Access Compliance Report

Public Rights-of-Way

Intersection ID: 14311	Main Street: BERKELEY_AV	Cross Street: CARLTON_AV	Location: S
ADA ID: 416C41A17F43	Ramp Type: BlendTrans2	Initial Pass/Fail: Fail	Overall Compliance: No
		Severity Score: 12.5

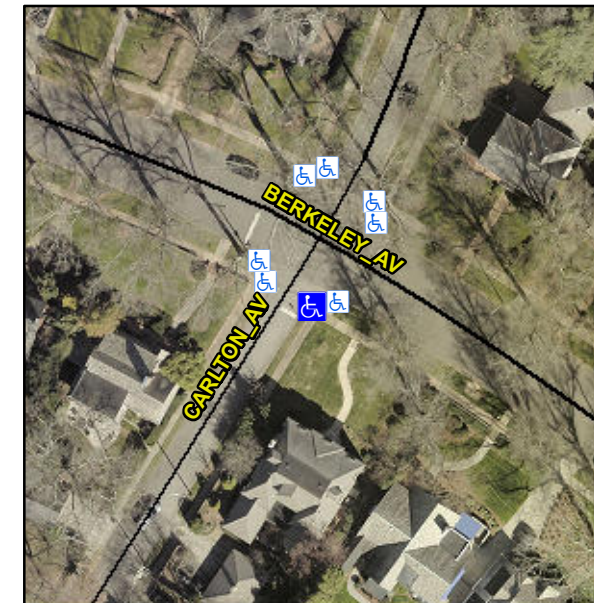
R304.5.3

Compliance	Description	Data	Compliance	Description	Data
N/A	Ramp Length (in)	70.0	Yes	BlendTrans Slope (%)	0.1
Yes	Ramp Width (in)	59.5	No	BlendTrans XSlope (%)	6.3
N/A	Flare Type LT	N/A	N/A	Flare Type RT	N/A
N/A	Flare Slope LT (%)	N/A	N/A	Flare Slope RT (%)	N/A
N/A	Flare Traversable LT?	N/A	N/A	Flare Traversable RT?	N/A
N/A	Landing Length (in)	N/A	N/A	DWS Provided?	N/A
N/A	Landing Width (in)	N/A	N/A	DWS Contrast?	N/A
N/A	Landing Slope (%)	N/A	N/A	DWS Length (in)	N/A
N/A	Landing X Slope (%)	N/A	N/A	DWS Full Width?	N/A
N/A	Landing Curb? (Y/N)	N/A	N/A	DWS Offset (in)	N/A
N/A	Shared Landing?	N/A			
N/A	Gutter Ponding?	N/A	N/A	Gutter Slope (%)	N/A
N/A	Gutter Lip Ht (in)	1.0	N/A	Gutter X Slope (%)	N/A
N/A	Painted X Walk1?	No	N/A	Painted X Walk2?	N/A
	X Walk 1 Direction	To NW		X Walk 2 Direction	N/A
	X Walk 1 Width (in)	N/A		X Walk 2 Width (in)	N/A
	X Walk 1 Slope (%)	5.5		X Walk 2 Slope (%)	N/A
	X Walk 1 X Slope (%)	2.8		X Walk 2 X Slope (%)	N/A

Remove & Replace Curb Ramp With Two New Directional Ramps or Equivalent.
